**TRAFFIC CONTROL SYSTEM**  
 Lighting Layout  
 Sta. 19+00-23+00

10th Ave sw ( ND Hwy 6 )  
 Mandan N.D.

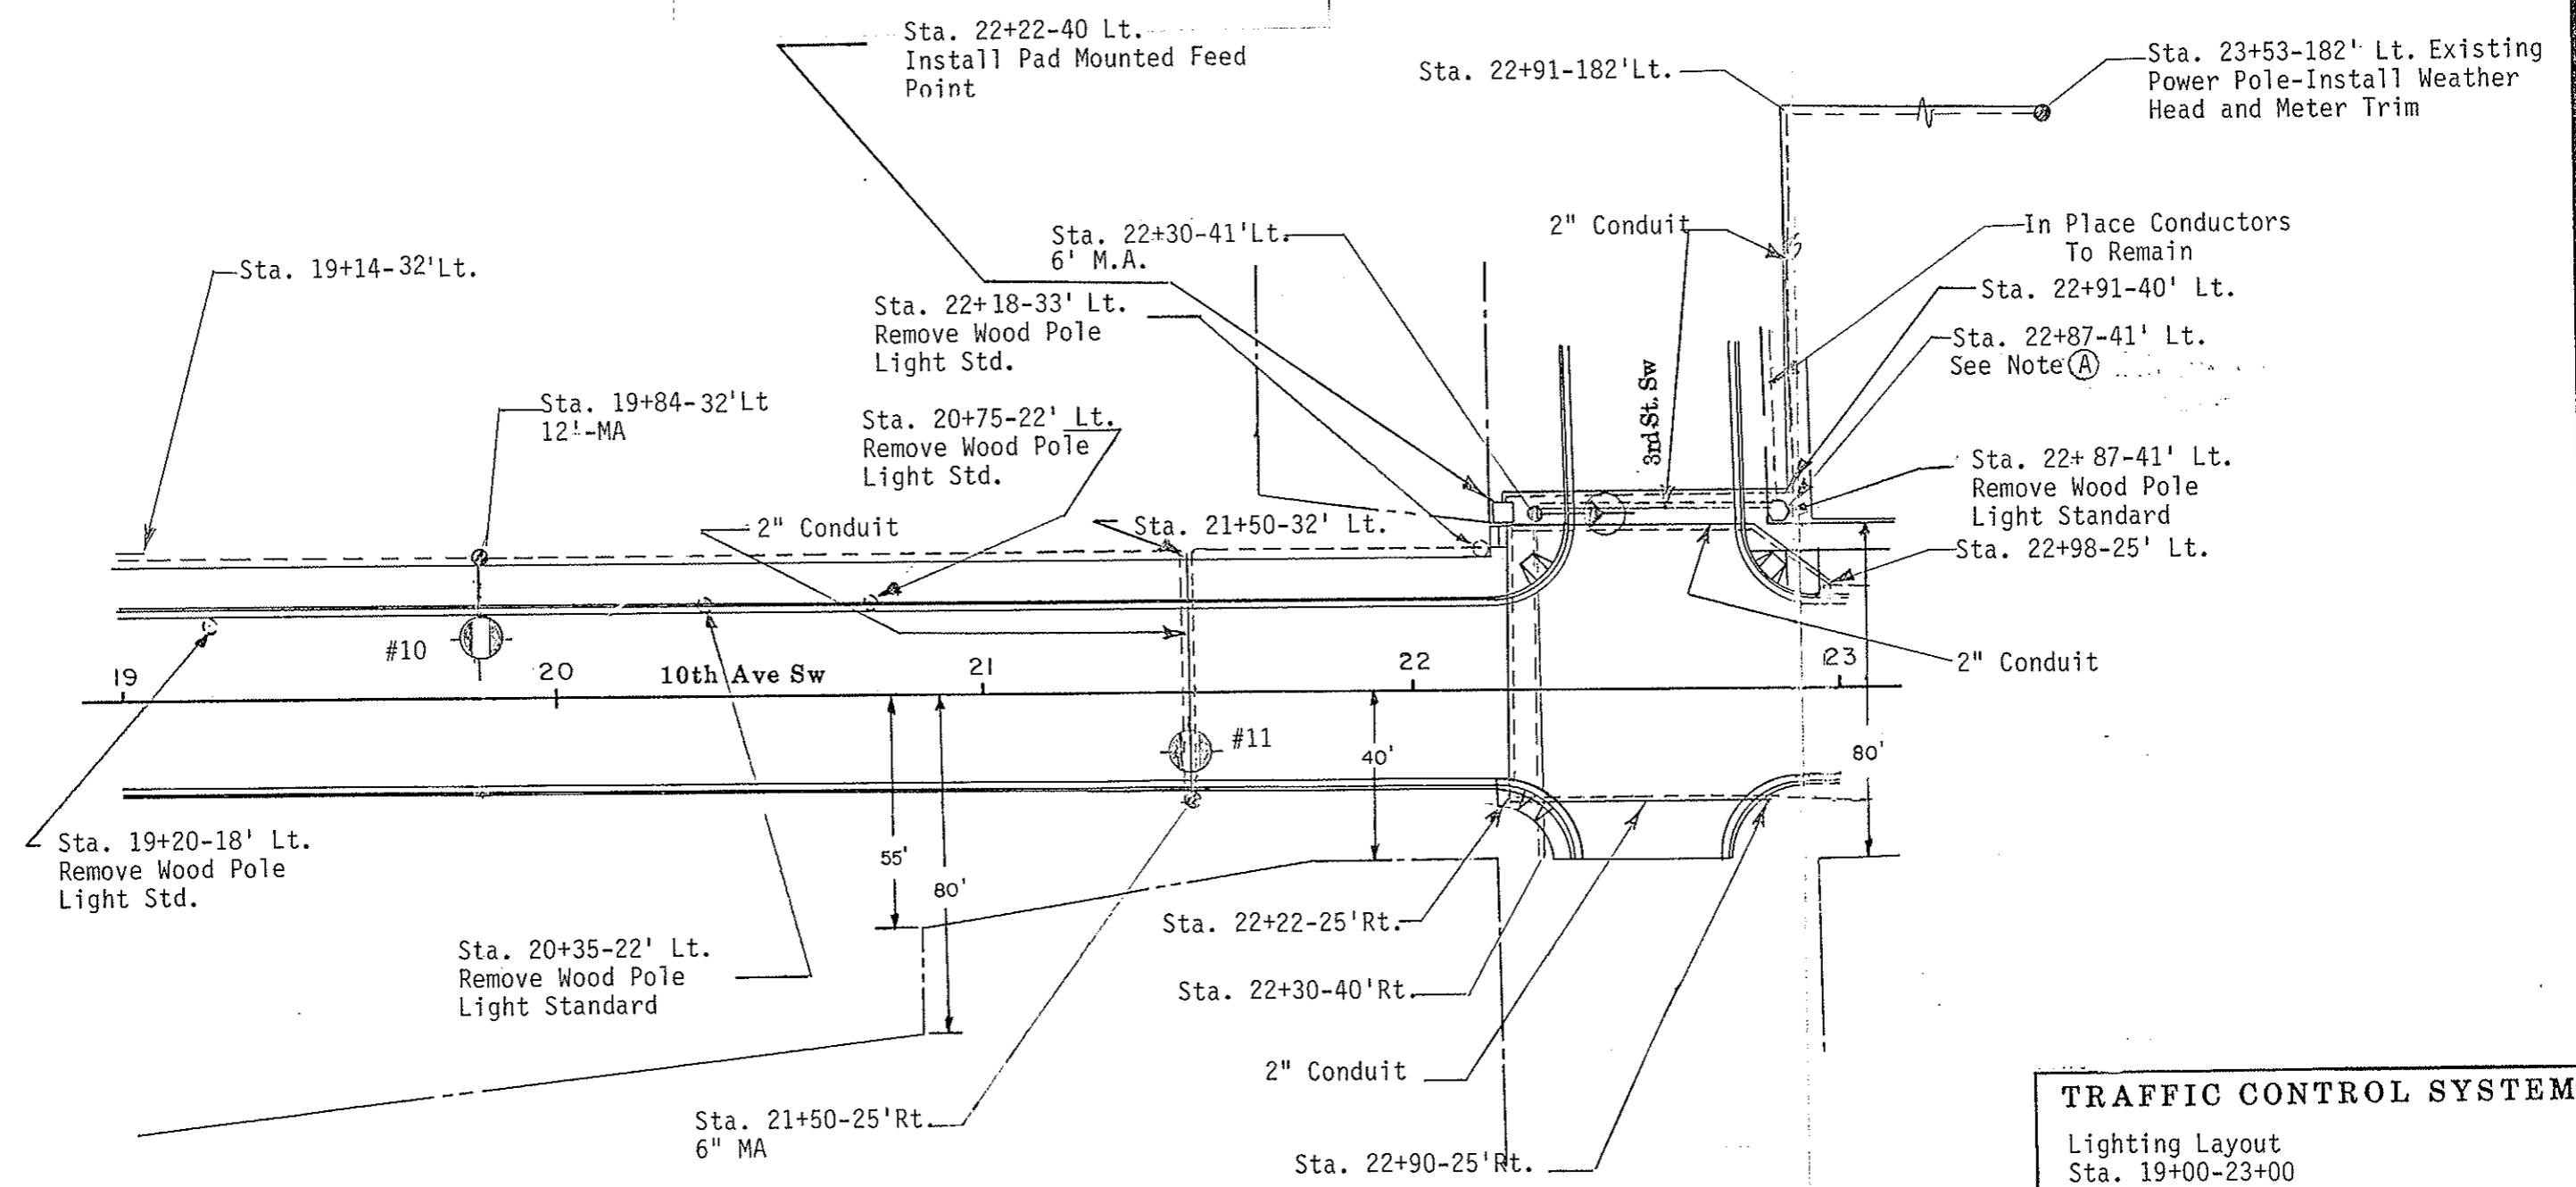
① Revised 1-18-91
